Access Compliance Report

Public Rights-of-Way

Intersection ID: 16738	Main Street: BEVERLY_DR	Cross Street: SHERWOOD_AV	Location: NW
ADA ID: 44270978B360	Ramp Type: PerpDiag	Initial Pass/Fail: Fail	Overall Compliance: No
		Severity Score: 35

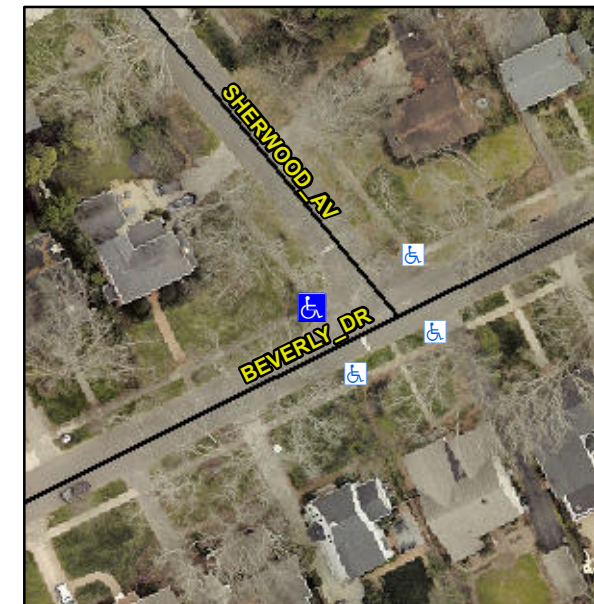
Not Found, R304.5.1, R304.2.2, R304.5.3

Compliance	Description	Data	Compliance	Description	Data
N/A	Ramp Length (in)	74.0	No	Ramp Slope (%)	12.9
No	Ramp Width (in)	43.0	No	Ramp XSlope (%)	2.7
N/A	Flare Type LT	N/A	N/A	Flare Type RT	N/A
N/A	Flare Slope LT (%)	N/A	N/A	Flare Slope RT (%)	N/A
N/A	Flare Traversable LT?	N/A	N/A	Flare Traversable RT?	N/A
N/A	Landing Length (in)	N/A	N/A	DWS Provided?	N/A
N/A	Landing Width (in)	N/A	N/A	DWS Contrast?	N/A
N/A	Landing Slope (%)	N/A	N/A	DWS Length (in)	N/A
N/A	Landing X Slope (%)	N/A	N/A	DWS Full Width?	N/A
N/A	Landing Curb? (Y/N)	N/A	N/A	DWS Offset (in)	N/A
N/A	Shared Landing?	N/A			
N/A	Gutter Ponding?	N/A	N/A	Gutter Slope (%)	N/A
N/A	Gutter Lip Ht (in)	N/A	N/A	Gutter X Slope (%)	N/A
N/A	Painted X Walk1?	No	N/A	Painted X Walk2?	No
	X Walk 1 Direction	To S		X Walk 2 Direction	To E
N/A	X Walk 1 Width (in)	N/A	N/A	X Walk 2 Width (in)	N/A
	X Walk 1 Slope (%)	0.1		X Walk 2 Slope (%)	2.0
	X Walk 1 X Slope (%)	1.1		X Walk 2 X Slope (%)	2.4

Remove & Replace Curb Ramp With Two New Directional Ramps or Equivalent.
